PD Modification Application: MM 22-1228

Zoning Hearing Master Date: January 17, 2023

1.0 APPLICATION SUMMARY

AGENCY REVIEW COMMENT SHEET

8.2 Proposed Site Plan (Full)

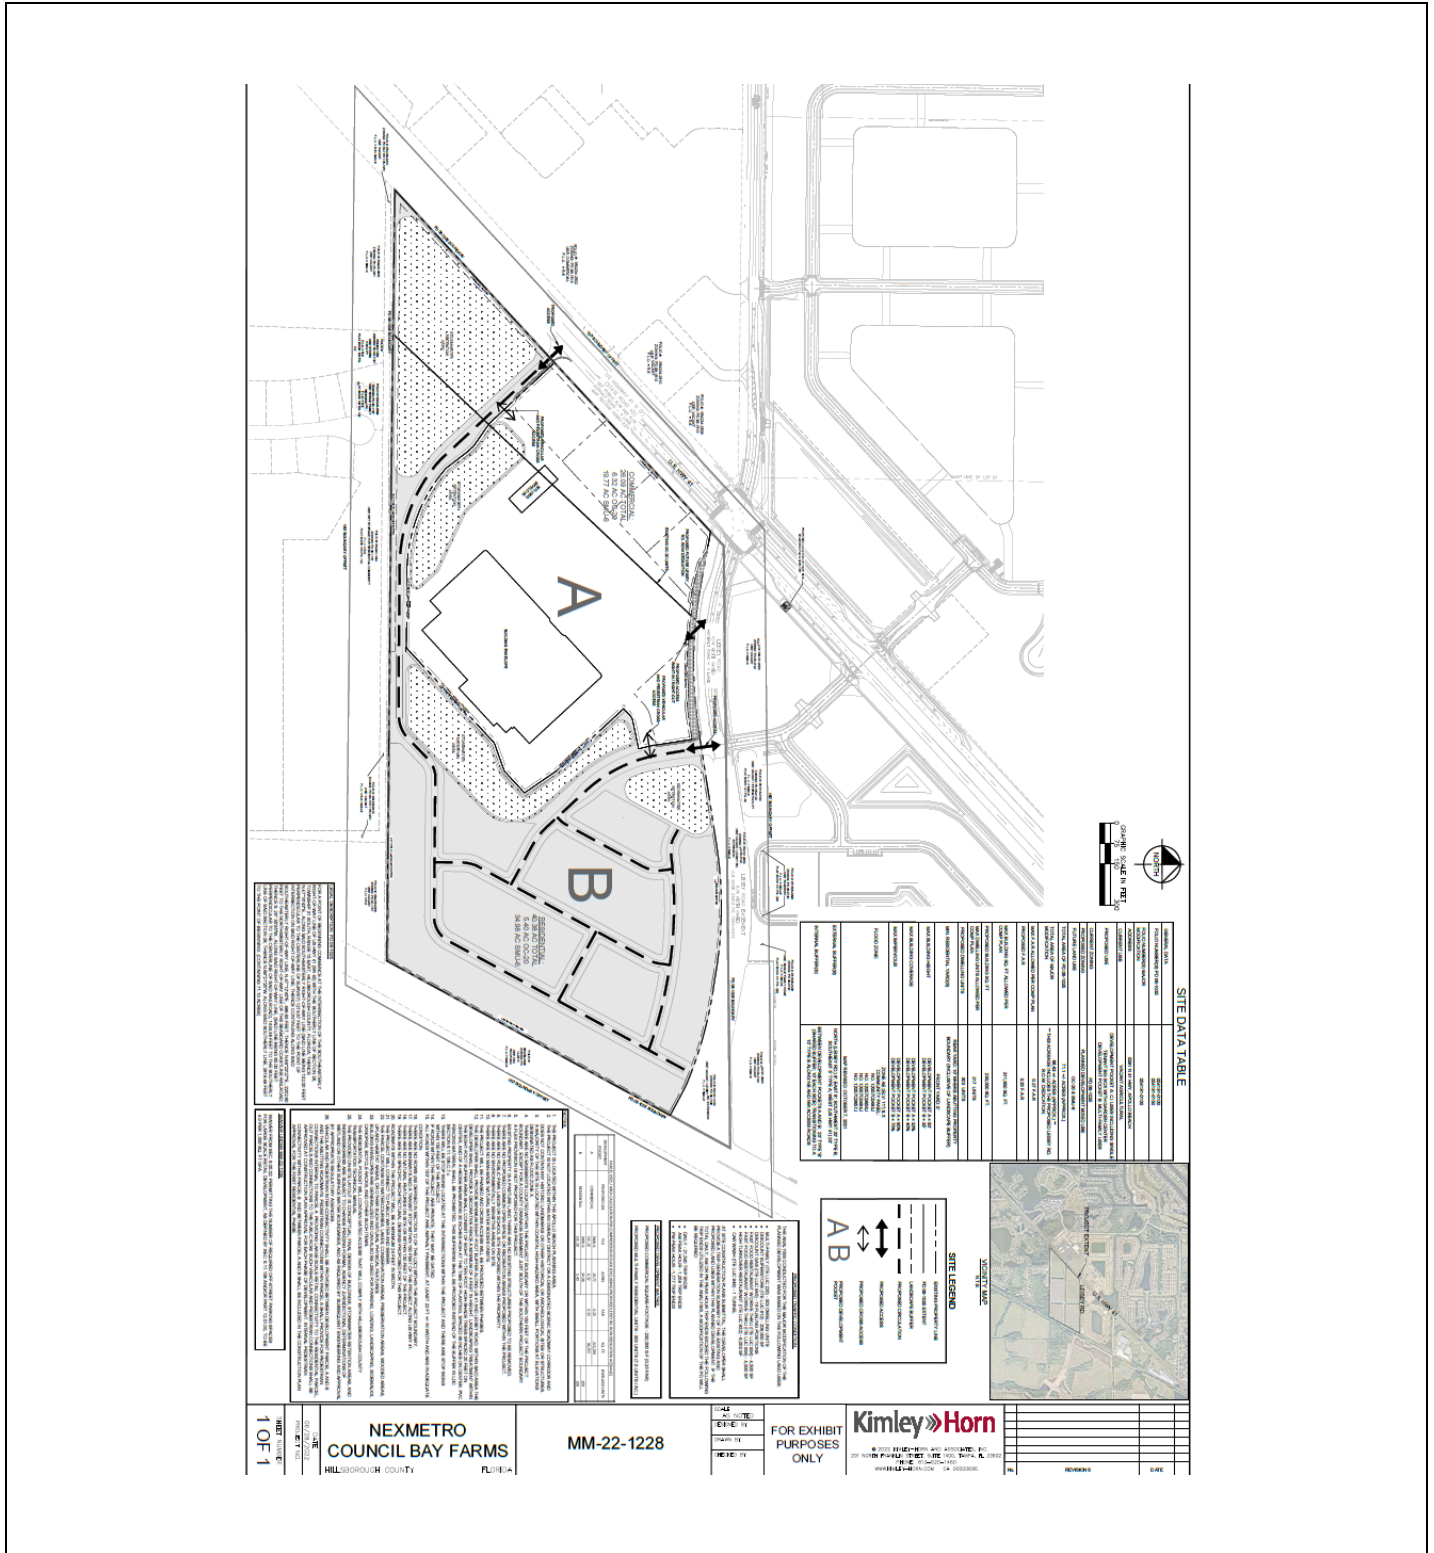
Prior to PD site plan certification, applicant shall:

1. Modify the label reading “Proposed Access Right-In/Right-Out” to read “Proposed Right-in Only Access – See Conditions of Approval”.
2. Modify the labels reading “Proposed Vehicular and Pedestrian Cross Access” to read “Proposed Vehicular and Pedestrian Access/Interconnectivity”.

3. Modify the label reading “Proposed Access” at US 41 to read “Proposed Pedestrian and Left-In/Right-In/Right-Out Vehicular Access – See Conditions of Approval”.

4. Modify the label reading “Proposed future Leisey Rd. ROW Dedication” to read “Up to +/- 29 feet Right-of-way Dedication Per Hillsborough County Corridor Preservation Plan – See Conditions of Approval”.

5. The applicant shall revise the site plan to replace all instances of “R/W Width Varies” along Leisey Rd. with labels which read “Right-of-Way Width Varies Between ____ feet and ____ feet”. Additionally, the applicant shall show and label the locations of the minimum and maximum extents of variance.

6. The applicant shall update the adjacent PD zoning information to display accurate zoning information. For example, the applicant shows the PD to the south labeled at 05-1951 while the County’s zoning atlas (i.e. GIS viewer) indicates the correct number is # 20-1029.

7. Modify site note 11 to instead state “The project will be developed in phases. Vehicular and pedestrian interconnectivity to be provided between phase, and access points to Leisey Rd. and US 41 and shared by development within Pockets A and B.”

8. Modify site note 14 to state “Internal project driveways will be privately owned and maintained. Portions of driveways serving only multi-family uses may be gated. Any internal private roadways may be public or private and, if private, may be gated. All facilities within the project will be constructed to applicable Transportation Technical Manual (TTM) and LDC standards. All residential gates shall comply with Typical Detail – 9 within the TTM.” Staff notes that this change combines notes 14 and 24, so please delete note 24.

9. Modify site note 17 to add “Transit accommodations will be provided – see conditions of zoning approval.”
10. Delete the portion of note 25 indicating that ingress and egress is “conceptual”. Staff notes that PD zonings are site plan controlled zoning districts. Only minor deviations to project access are permitted at the time of plat/site/construction plan review. More substantial access changes or relocation will require a modification to the PD.

11. Add a note indicating that “Parking will be provided in accordance with Section 6.05 of the LDC and the PD variation approved concurrently with MM 22-1228 – see zoning conditions of approval.”

12. Delete the box and information within the box titled “Waiver Under MM-22-1228”.
